**WICKS BOULEVARD SIDEWALK
PROJECT NO. 09-144-36-287
BID NO. 08-09.024**

ADDENDUM NO. 1

June 11, 2009

RETAINING WALL DETAIL

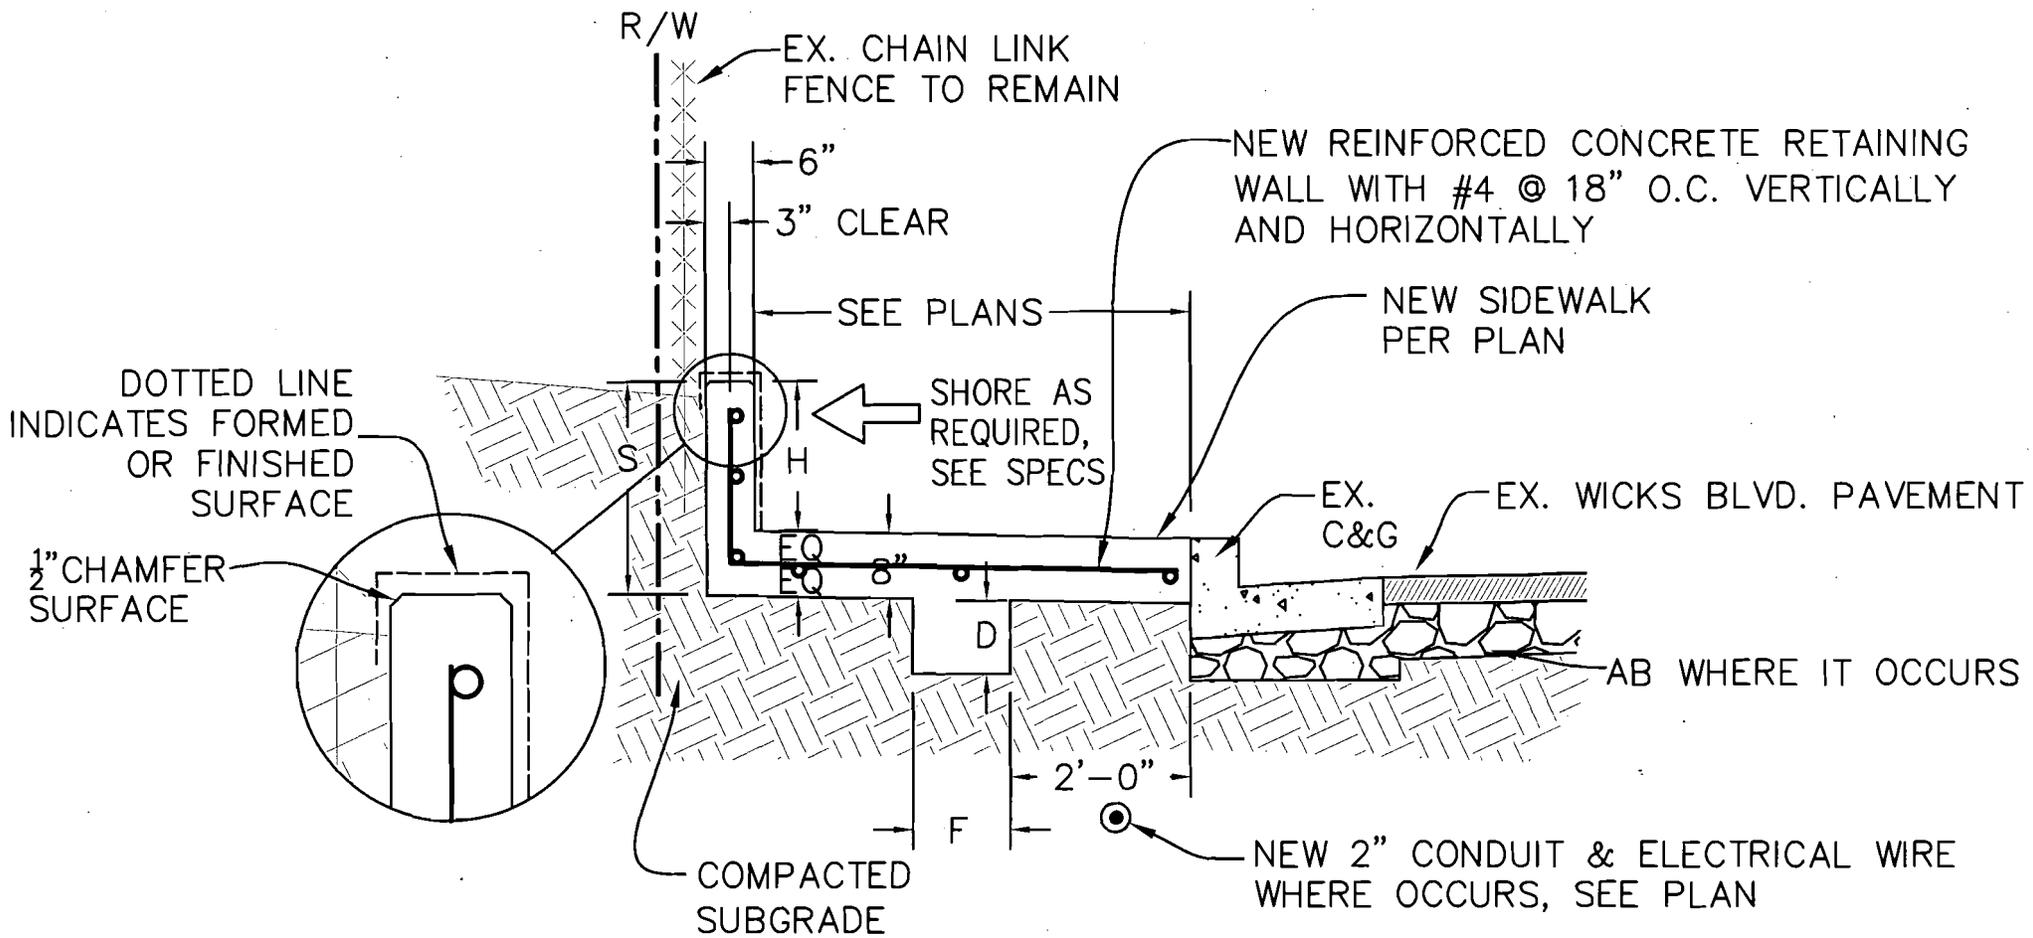
Plan Sheet 7 has been modified. Addendum Number 1 is attached. Detail A on Plan Sheet 7 shall be replaced by Detail A attached.

H	S	F	D	STATION
1.75'	2.42'	.5'	.5'	4+77 TO 5+32
1.25'	1.92'	0	0	5+32 TO 5+75
1.00'	1.67'	0	0	4+00 TO 4+77

FROM STA. 4+00 TO 5+75

ALL WALLS/CURBS SHALL HAVE 45° TRANSITIONS AT START AND END WITH ROUNDED EDGES
